## **Grant Community Club**

Accessibility Review

City of Duluth, MN

**Photo 3:** Eliminate the 1" rise where the addition connects to the original structure.

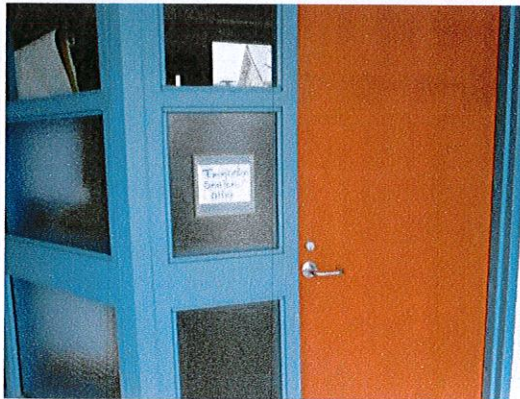
**Photo 1:** There is 1 sign designating an accessible parking space.

**Photo 2:** Create an accessible route to the main entry. There is currently a step.

**Photo 4:** Typical hardware is lever style and raised and braille signs are provided throughout the building. *This is a good example of accessibility.* Remove the paper that is covering the signs.

**Photo 5:** View of single-user toilet room. *This is a good example of accessibility.*
